No:26-034

Perry County Subdivision/Land Development Review Report

Municipality	Watts Township	Surveyor	Gregory L. Condon	Engineer	Adam M. Citrullo		
Plat Title	MRPI Amity Hall, LLC Susquehanna Crossings						
Zoning District	I - Industrial, C-1 Commercial, and AR - Agriculture/ Rural		Proposed Land Use	Industrial (Industrial), and lot additions (LAD)			
Plat Status:	X Preliminary	Plat Type:	Subdivision	Regulations:	County		
	Final		Land Development		X Municipal		
	P/F		X Combined		X Zoning		
	Minor				X S&LD		
# of New Lots	0	# of New Dwelling Units	0	Acreage Subdivided	286.88	Total Acreage	486.88
Date Received	03/25/2026	Staff Review	04/14/2026	Official County Review	04/14/2026

HEET NUMBER:
LC-03

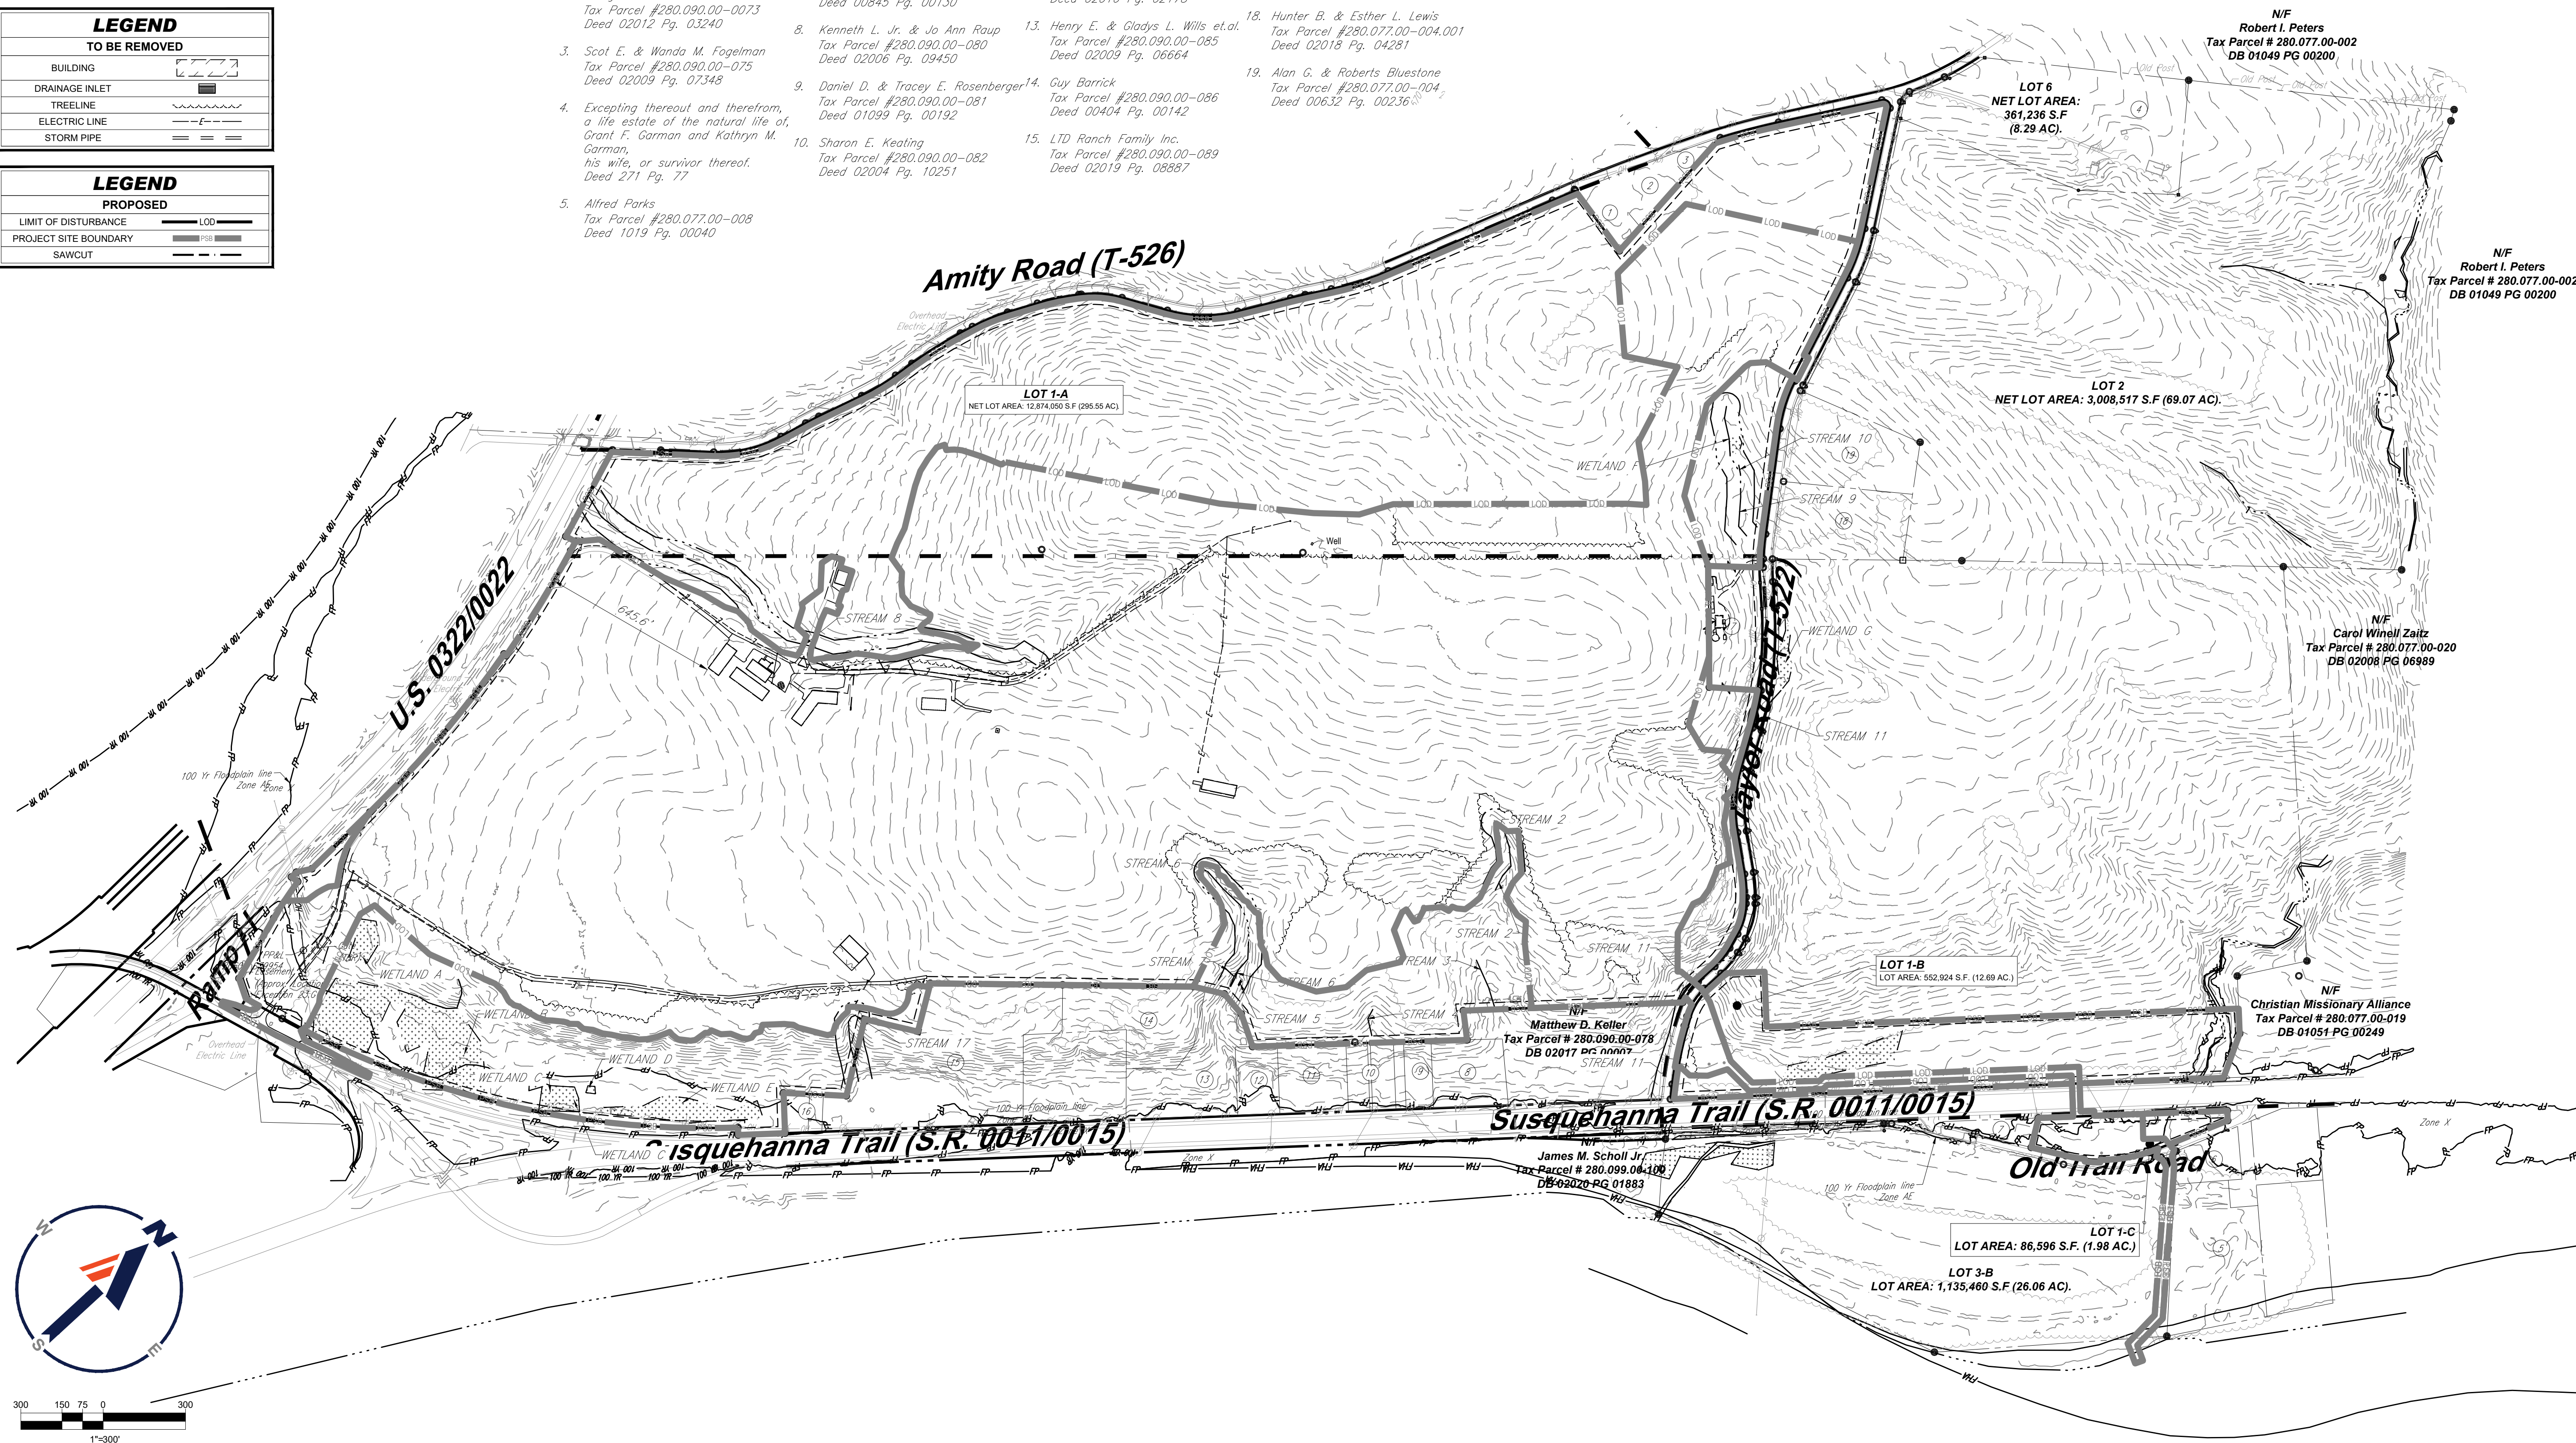
13. There appears to be lot area overlap and replication. On plan Sheet LC-3 two lots are described as 1.98 acres (Lot 1-C and Lot 5); Lot 3 appears to include areas listed as Lot 3A and 3B although they are not displayed as being contiguous.
